Division: Environmental Consulting
Your Reference:
Our Reference: 16580
Date: 04 November 2020

VISUAL SPECIALIST COMMENT IN RESPECT OF PROPOSED AMENDMENTS TO THE ENVIRONMENTAL AUTHORISATION FOR THE PROPOSED KUDUSBERG WEF NEAR MATJIESFONTEIN, WESTERN CAPE PROVINCE

Figure 2: Layout map for proposed Oya WEF (northern section of the authorised WEF)

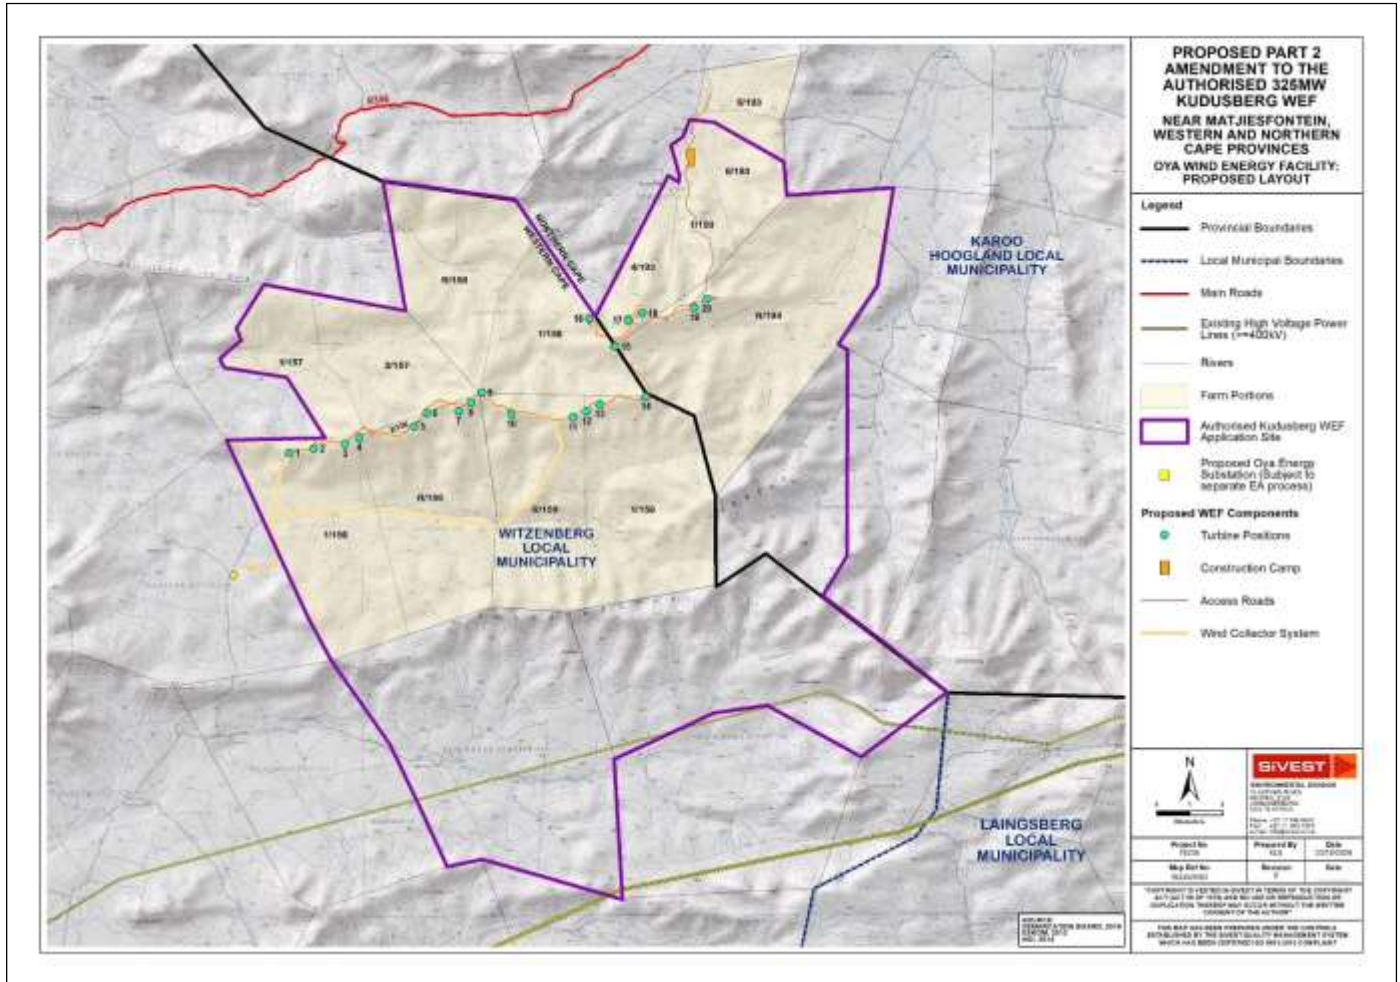
The amended layouts for the Kudusberg WEF and the Oya WEF have taken cognisance of the areas of visual sensitivity identified in the original VIA. Furthermore, the smaller turbines proposed for the Oya WEF will be less visible

from the surrounding area, thus reducing the visual sensitivity of the Oya WEF site. As such, the proposed amendments will not result in any changes in the findings of the visual sensitivity analysis.

In addition, the proposed Oya WEF layout, including the turbine positions and construction camp site, is considered acceptable from a visual impact perspective and should be authorised as final. The proposed mitigation measures identified in the original Kudusberg WEF VIA are still valid for the Oya WEF and no additional recommendations or mitigation measures will be required.

Figure 3: Layout map for proposed Kudusberg WEF (southern section of the authorised WEF)

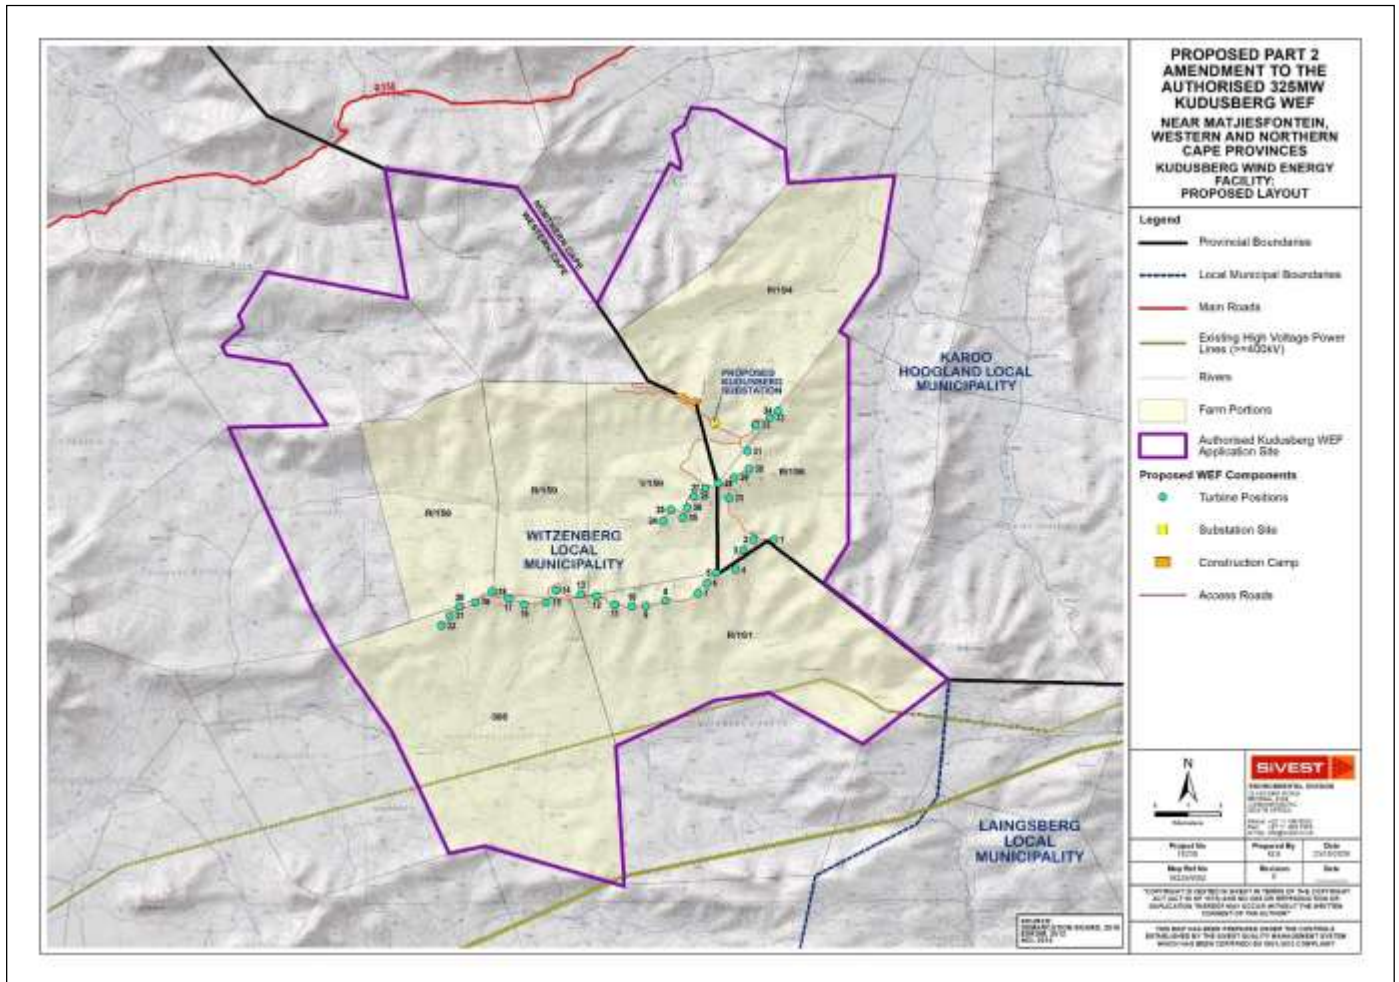
The amended turbine layouts will only affect one potentially sensitive receptor, this being VR13. The proximity of the nearest turbine to this receptor increases the impact rating for this receptor from Moderate to High. As this receptor is located on the Kudusberg WEF development site however, it is assumed that the owner of this receptor has a vested interest in the development and as such would not perceive the WEF in a negative light.

The proposed changes to the authorised road and turbine layouts, the position of the authorised construction camp and the provision of a new construction camp site to serve the smaller Kudusberg WEF are all considered acceptable from a visual perspective.
